Re - Planning Application 2024/0447/01/DET

Proposed BES Wallbottle Road, Newburn

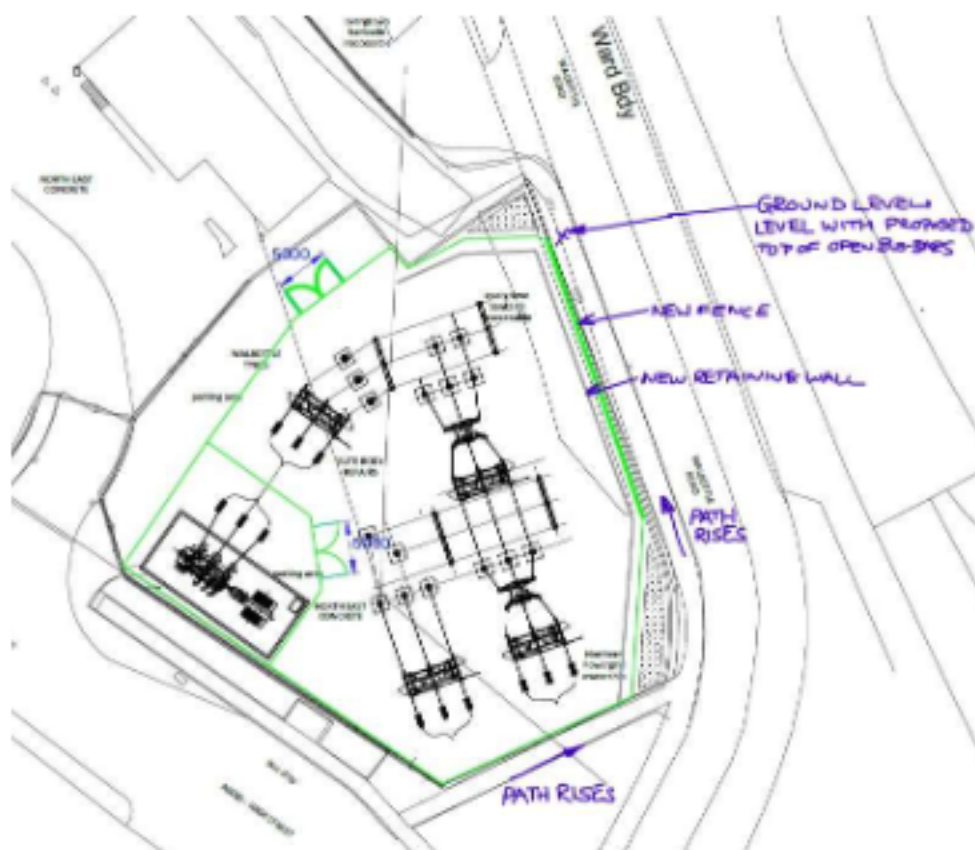
From the front corner of the DNO substation the path rises with Wallbottle Road. The perimeter of the substation is indicated to have only a 2.35m palisade metal security fence.

Yet if you refer to other local DNO substation of this voltage, there is also a 1m high electric fence on the top of the security fence. I can find no reference to this on the drawings or in the documents. But I'm sure it's going to be needed.

Given the way the Wallbottle Road raps around the site and rises as it goes you will note that as indicated on the plan above. The ground level on the road side external to the substation is at the same level as the open bus-bars within the sub-station. Given the nature of the proposed fencing. It would be possible and easy to push/through item's between the railings and have them make contact with the open 132kV bus-bars. This would be a highly dangerous thing to try and if managed would likely kill the person or at least short the bars out. Alternative fencing needs to be looked at for this stretch of the perimeter I would suggest.

I note that there is to be a new retaining wall to be constructed along the Walbottle Road perimeter. I can't find any height for this indicated. But what I would note is that both busses and heavy lorries (going to the waste recycling centre) regularly use this road. The slop on the road rises for another 75m approx. So if the road is icy or brakes fail, then there is a good distance for momentum to be built up before the perimeter is reached. Any form of vehicle leaving the road and entering at the high point of the sub-station could also make contact with the open bus-bars.

Therefore the new retaining wall should be of a height and strength to ensure that no vehicle could get through the perimeter fence/wall and enter the substation.
